Product Change Notice

Issue Date: 1 Feb-2021

Introduction of replacement die for below part numbers.

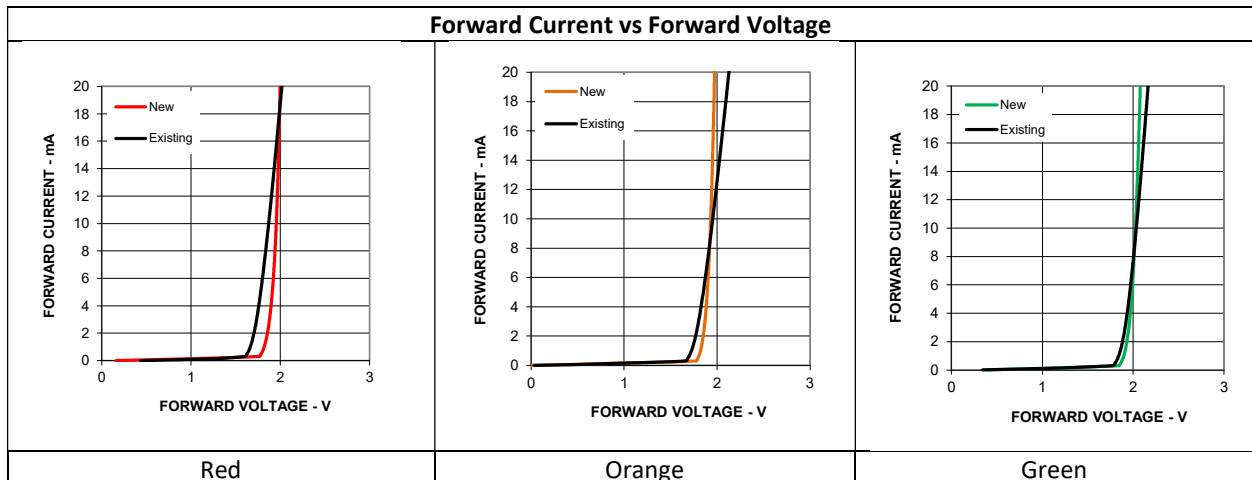
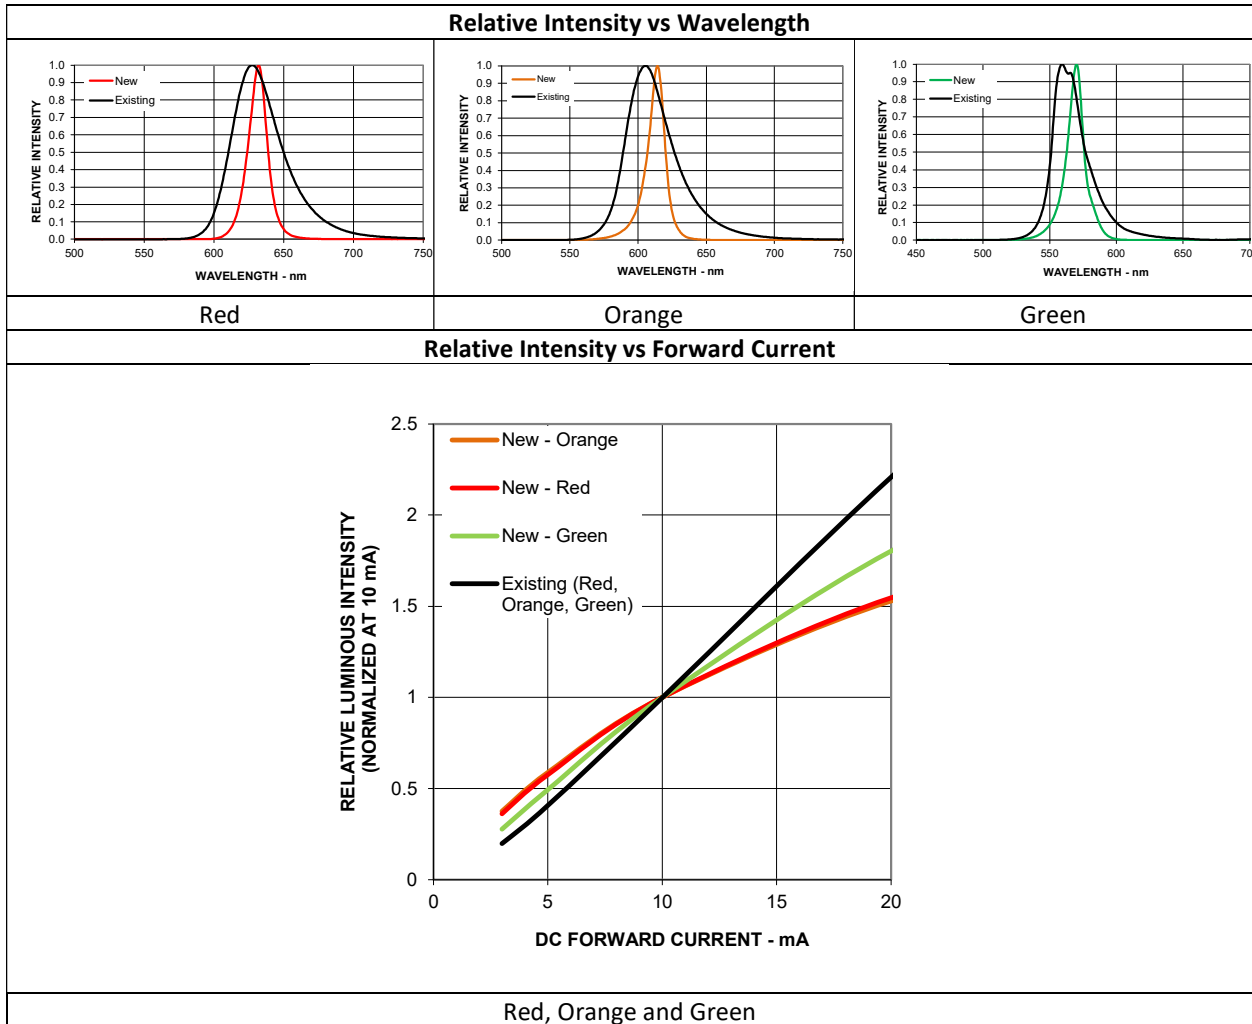
Following are the changes in product characteristic.

1. The Forward Voltage vs Forward Current.
2. Relative Intensity vs Wavelength
3. Relative Intensity vs Forward Current

The new die (AlInGaP) will replace the existing die (GaP) for all affected part numbers.
